**From:** Edmund Hobday <edmund@beandscape.co.uk>  
**Sent:** 25 May 2022 11:43  
**To:** Michael Graham  
**Cc:** Holly Tisson  
**Subject:** RE: Planning application 21/00857/FUL Acornfield Road, KBP  
**Attachments:** 21-59-03F@A0 Planting Plan.pdf; 21-59-02D@A0 Tree Protection Plan.pdf

**Subject:** Planning application 21/00857/FUL Acornfield Road, KBP

**project:**  
SITE 2, IMAGE BUSINESS PARK  
KNOWSLEY

**title:**  
TREE PROTECTION PLAN

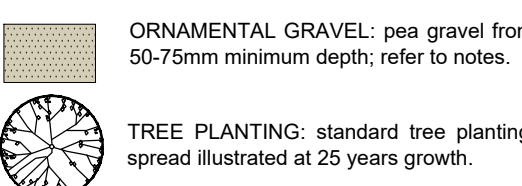
- 4a, BEA Landscape's updated landscape plan ref 21-59-03E in which the hedge to the internal site access road matches the hedge in 21/00857/FUL (species is *escallonia rubra macrantha*). – **Apologies this was not the hedge referred to it was the one with the mix (as this will be seen from the main streetscape along Acornfield Road), so please replace the mix:**

With a simpler hedge mix, which should be set as a double staggered row 5/Lm, within this space (either at the front or back of the bed, with the wildflower grass seed mix over the rest of the area):

Acer campestre (\*) 20%  
Corylus avellana (\*) 20%  
Crataegus monogyna (\*) 40%  
Ilex aquifolium (\*) 3L 10%  
Viburnum opulus (\*) 10%

With regard to the planting area by W1: This needs to have tree species introduced into the whip mix for this area to help strengthen the reduced woodland, so species like Quercus robur, Carpinus Betula and Pinus Sylvestris (these can be planted at 2m centres with understorey species i.e. Corylus, ilex etc in between). Noted, the landscape plan will be amended accordingly whilst having in mind the proximity of new tree planting relative to the building itself.

We have replaced the native shrub planting with a hedge and wildflower grass as requested to Acornfield Road however we have not extended the hedge behind the existing utility building as the width is too narrow between the retaining wall and boundary fence for a viable area of wildflower grass. We have therefore included an area of native shrub planting here.

The planting area adjacent to W1 has been simplified and *Pinus sylvestris*, *Carpinus betulus* and *Acer campestre* tree species introduced.

Noted, the landscape plan is being amended as requested and the hedge will be located at the front of the sloping bed and so be immediately behind the existing fencing to this section of the frontage.

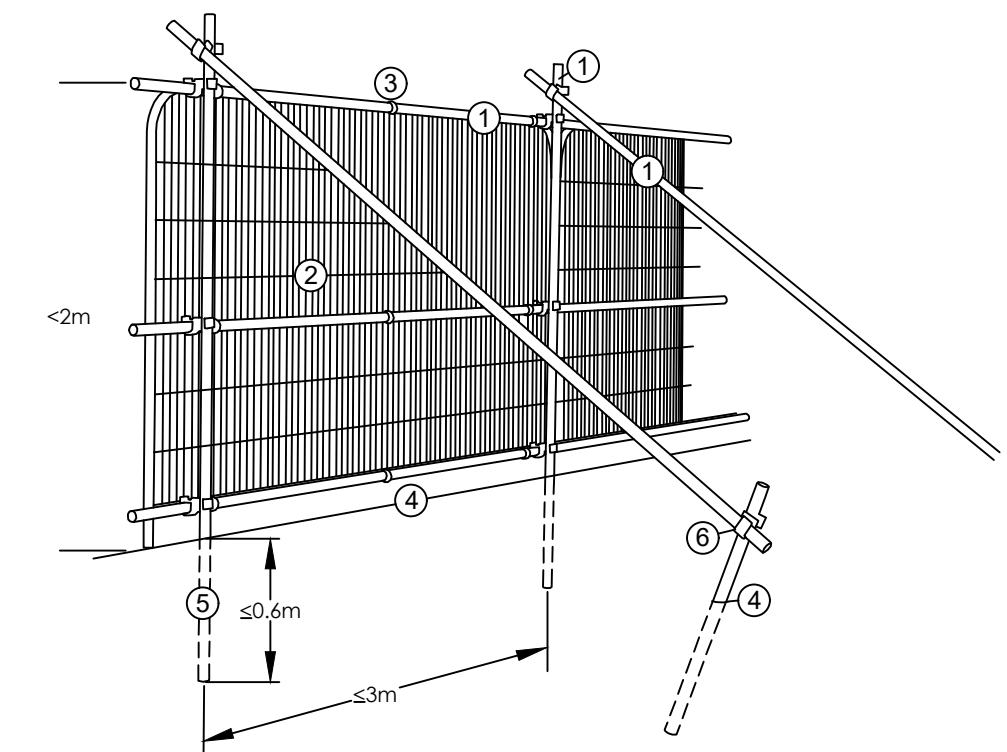
We have also reviewed the tree retention to W1 and included for the retention of an additional two trees to the boundary however space will be required for the installation of the 'sandbag retaining wall' which precludes the retention of further trees.

| rev | date:      | amendments:                           | alt: |
|-----|------------|---------------------------------------|------|
| D   | 24/05/2022 | Retained trees amended.               | E.H  |
